MARES SERVICE MANUAL

2010

R2S
1ST STAGE

**SUBJECT:
OCTOPUS MV COVER**

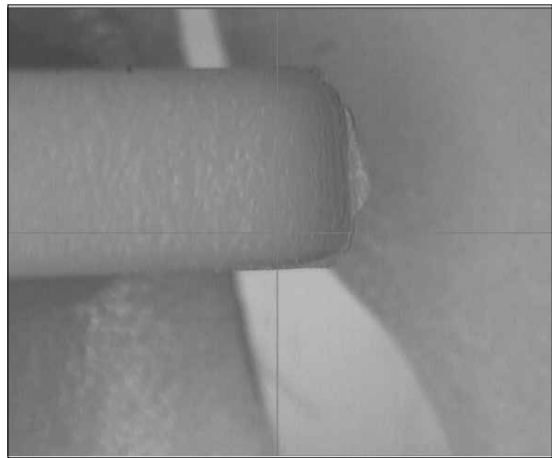
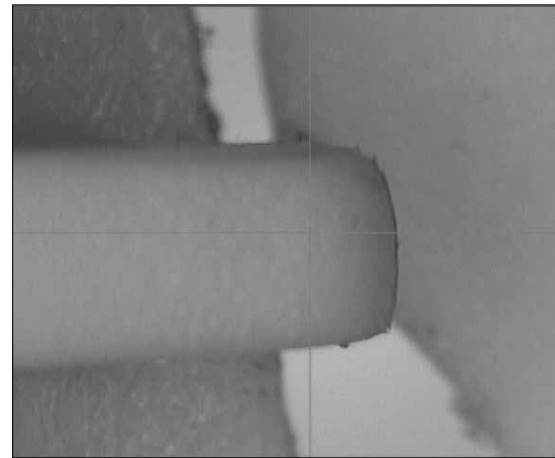
HAVING RECEIVED A NUMBER OF REPORTS, MARES SPA TECHNICAL SUPPORT REQUESTS THAT ALL MARES LAB PARTNERS, WHEN CARRYING OUT PERIODIC INSPECTIONS, CHECK FOR THE PRESENCE OF SMALL HOLES IN THE OVAL MEMBRANE OF THE SECOND STAGE (**CODE: 46187009**) AROUND THE METAL DISK (PHOTO 1). IF ANY HOLES ARE DISCOVERED THE OVAL MEMBRANE MUST BE REPLACED AND YOU MUST CHECK THE SURFACE OF THE PURGE BUTTON POPPET (**CODE: 46187028**) (PHOTO 2) TO CHECK FOR ANY RESIDUAL MATERIAL (PHOTO 3); IF SO REMOVE (PHOTO 4) USING A CUTTER FOR EXAMPLE, IN ORDER TO AVOID THE PROBLEM RETURNING WHEN REPLACING THE MEMBRANE.

MARES SPA ALSO RECOMMENDS CHECKING ANY STOCK OF MV COVERS KEPT AS SPARE PARTS AND THEN REMOVE THE PLASTIC RIDGE IF NEEDED.

**RE:
ABYSS 08 SECOND STAGE COVER****ITM19 BIS**

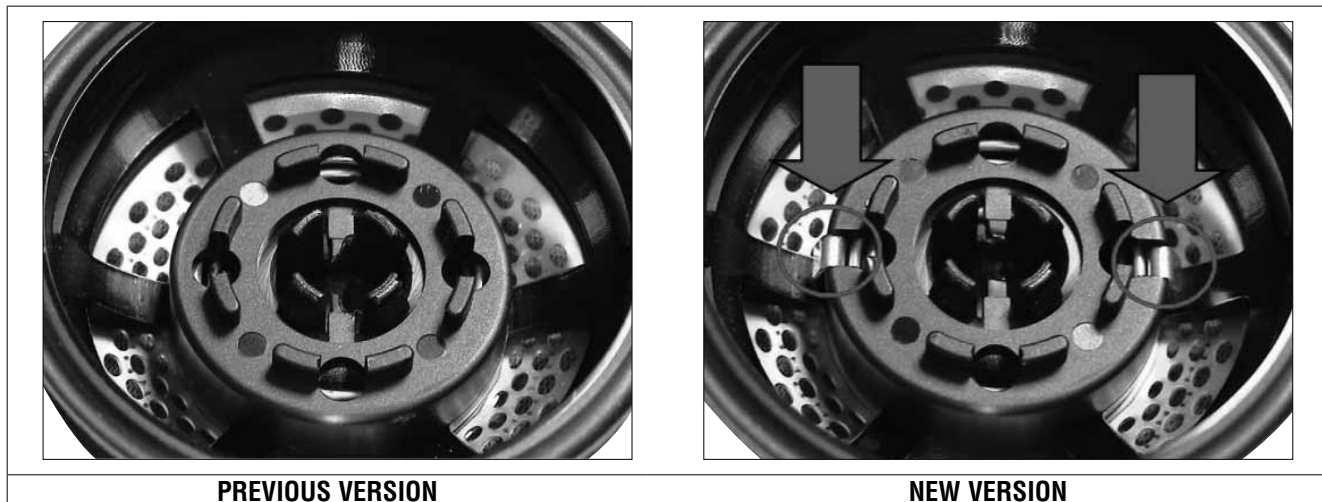
MARES TECHNICAL SUPPORT SERVICE IS PLEASED TO ANNOUNCE TO ITS MARES LAB SUPPORT CENTERS THAT AN IMPROVEMENT HAS BEEN MADE TO THE ABYSS SECOND STAGE COVER. THE CODES ASSOCIATED WITH THIS CHANGE ARE: 46200849-46200850-46200851. THE IMPROVEMENT CONCERNS THE SYSTEM FOR FASTENING THE METAL PLATE (MESH GRID) TO THE COVER. THIS NEW SOLUTION PREVENTS THE FRONT SECTION OF THE COVER FROM COMING OUT AFTER A STRONG BLOW (ESPECIALLY ON THE SURFACE).

THE NEW COVERS CAN BE IDENTIFIED BY THE TWO HOOKS INSIDE THE COVER, WHICH CAN BE SEEN IN THE PHOTO ON PAGE 2.

IN ADDITION, ABYSS SECOND STAGES THAT HAVE THE NEW COVER ASSEMBLED CAN BE IDENTIFIED BY THE PROGRESSIVE PRODUCT SERIAL NUMBER, STARTING WITH THE NUMBER SHOWN IN TABLE #1.

FIG. 2

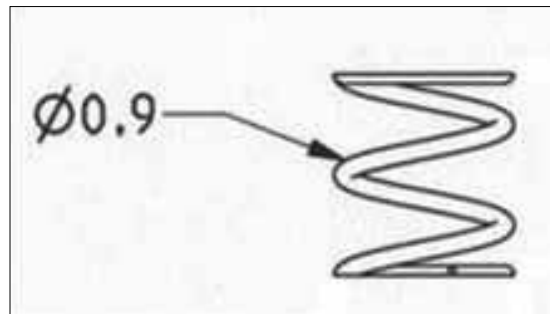
MARES S.P.A TECHNICAL SUPPORT ANNOUNCES THAT A NEW SPRING WILL BE ASSEMBLED FOR THE INFLATION BUTTON ON AIR-CONTROL (**CODE 416893**) THAT HAS SLIGHTLY GREATER THRUST THAN THE PREVIOUS SPRING AND ENSURES PERFECT OPERATIONS EVEN IN EXTREME CONDITIONS (DIRTY OR CONTAMINATED WATER).
THE NEW INFLATION BUTTON SPRING WILL BE ASSEMBLED BEGINNING FROM SERIAL NUMBER: **EC13569**.
THE CODE OF THE NEW VERSION IS #46201113. THE NEW SPRING CAN BE IDENTIFIED BY MEASURING THE DIAMETER OF THE SPIRAL, WHICH IS 0.9~MM (FIG. 1 AND FIG. 2).

PREVIOUS VERSION
COD. 47200744

CURRENT VERSION
COD. 46201113
